PROJECT NO. U-0620
CUMBERLAND COUNTY
 STATION: 161+95.29 -L-

SUBSTRUCTURE
 END BENT 2
 (RIGHT LANE)

REVISIONS						SHEET NO. 5-120
NO.	BY:	DATE:	NO.	BY:	DATE:	
1	M.G.S.	03-21-05	3			TOTAL SHEETS 129
2			4

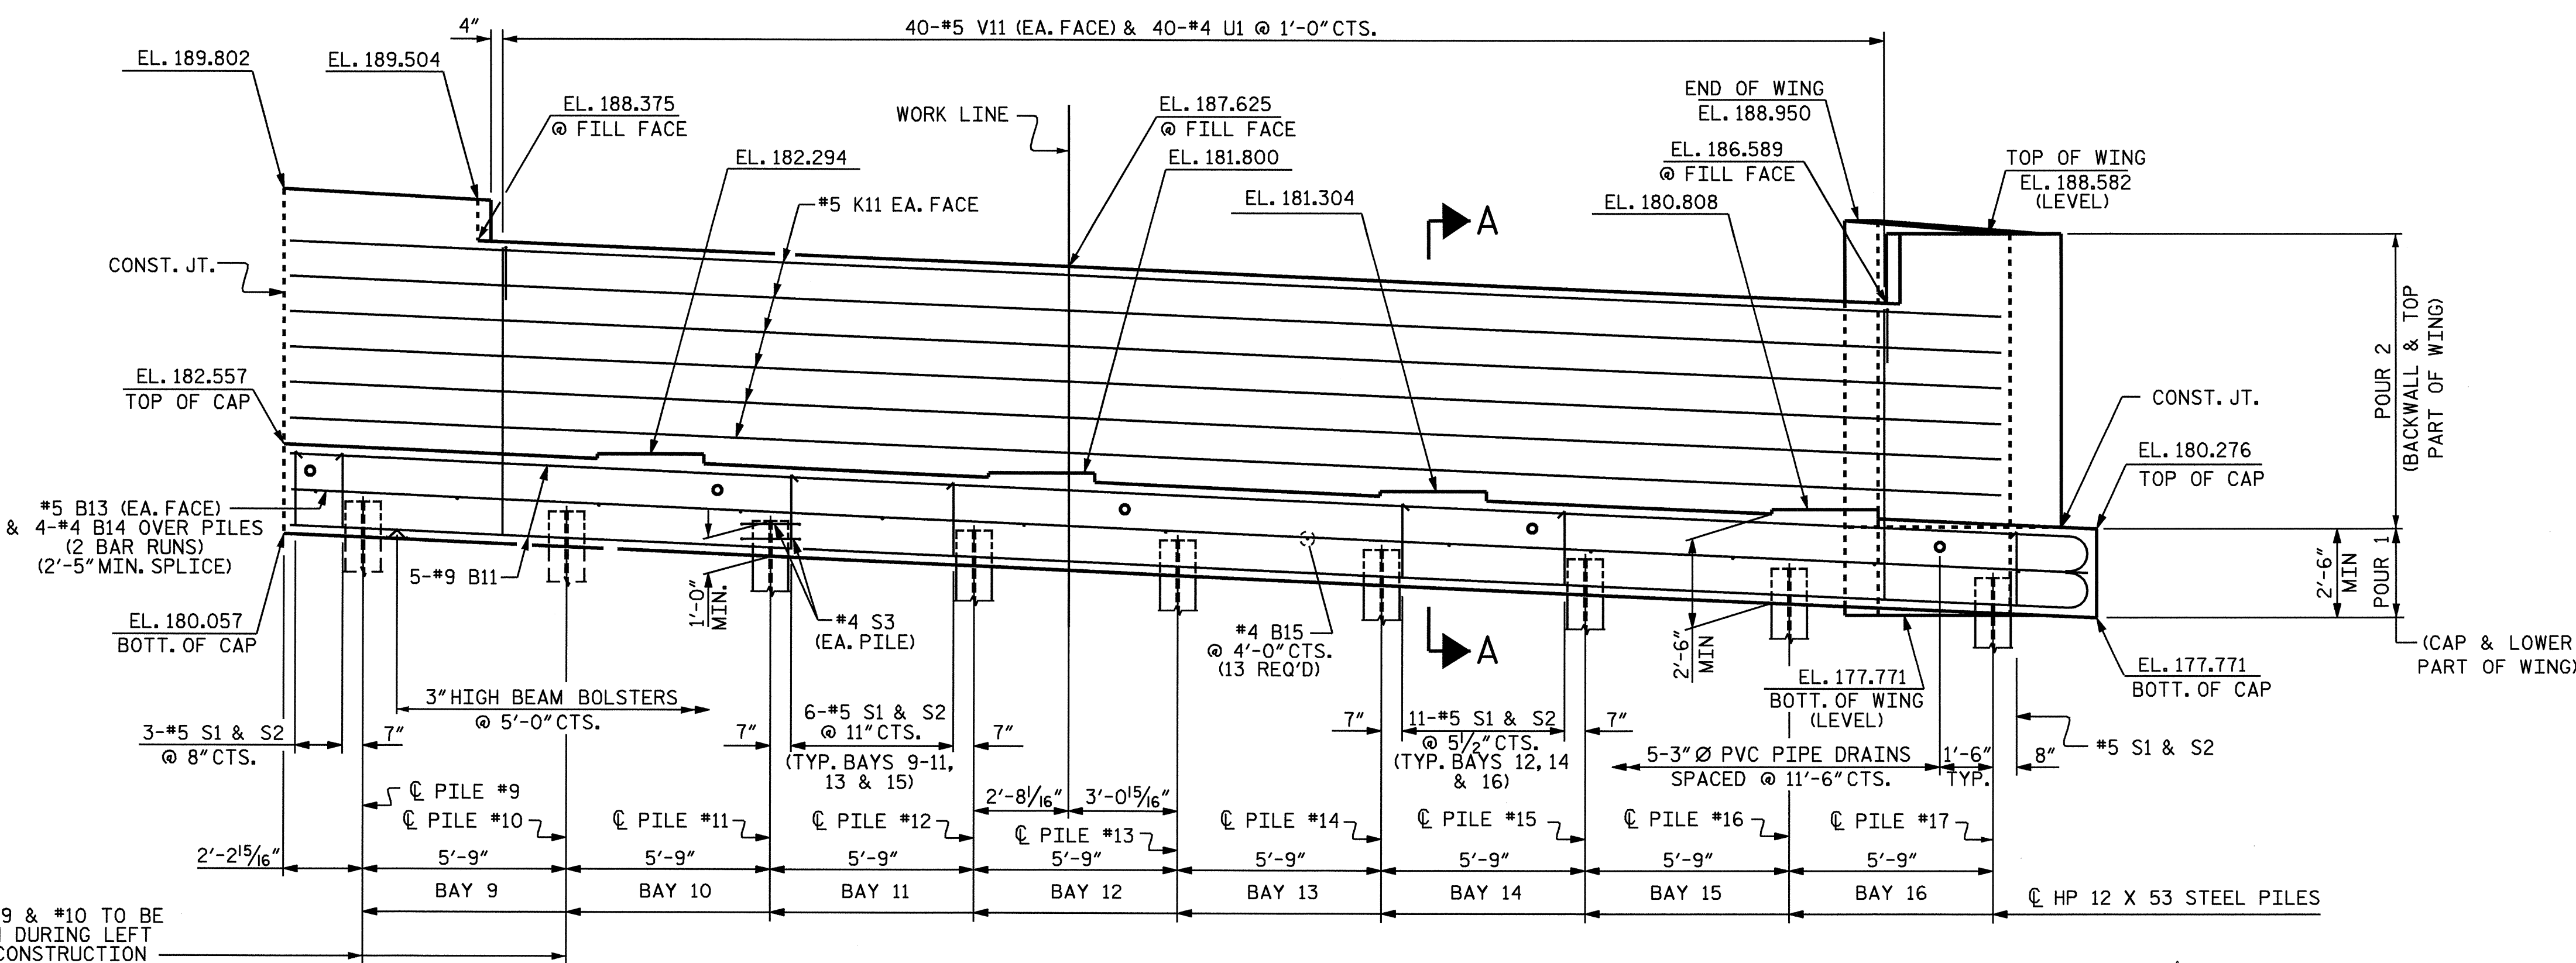
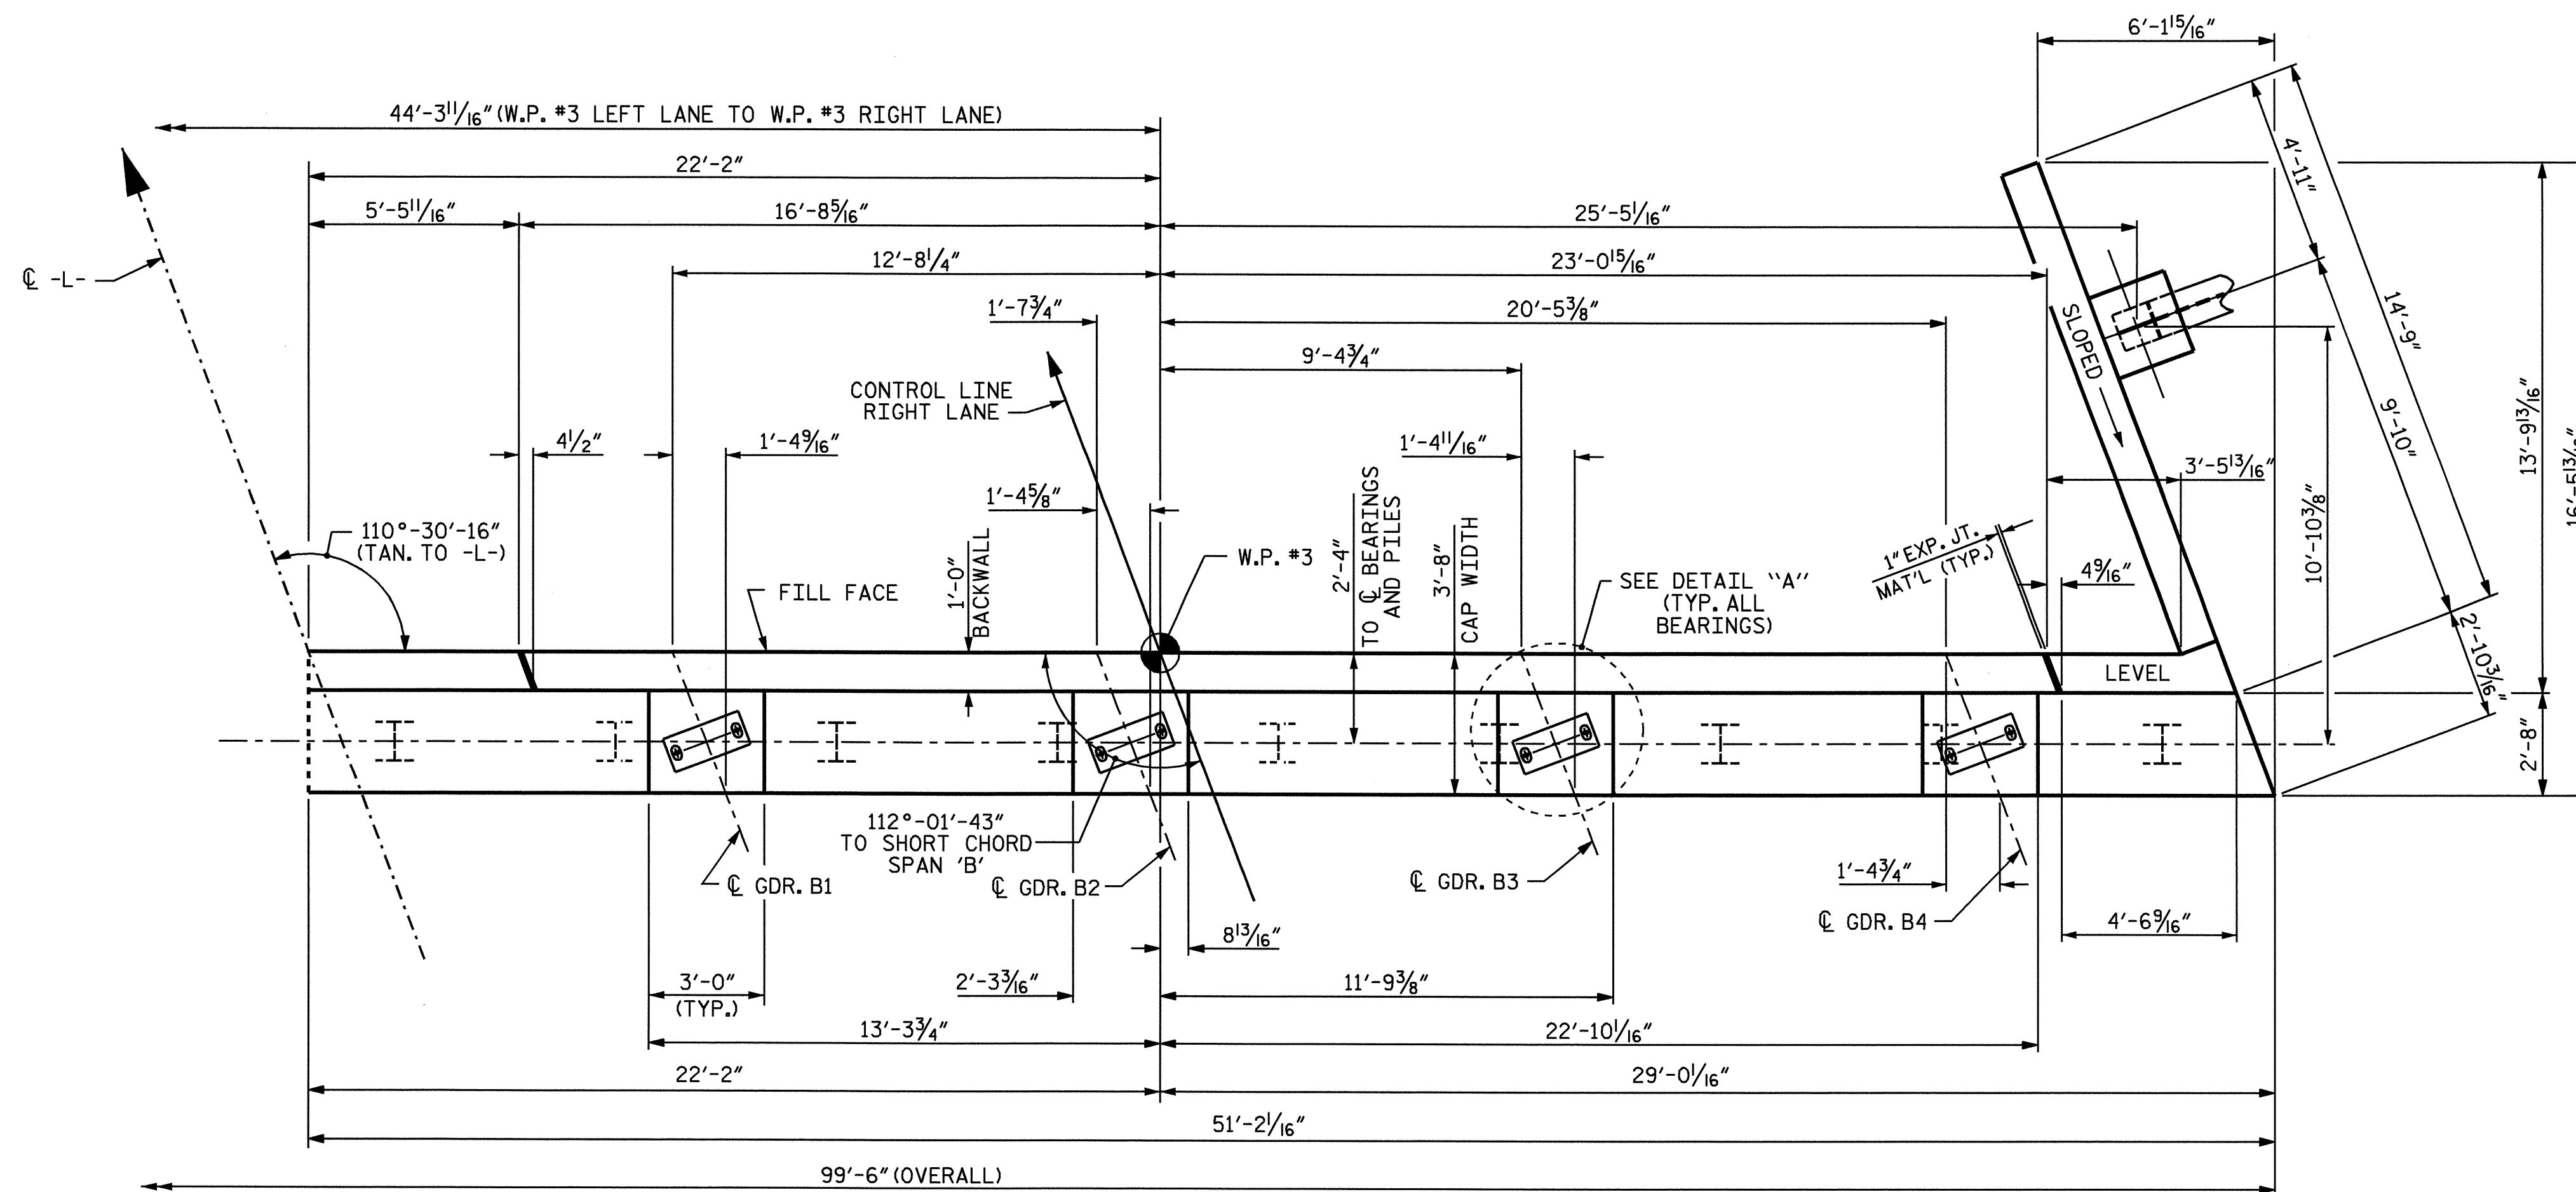
REV: CHANGE BRACE PILES TO VERTICAL PILES.
 DRAWN BY: M.G.S.
 CHECKED BY: B.D.K.
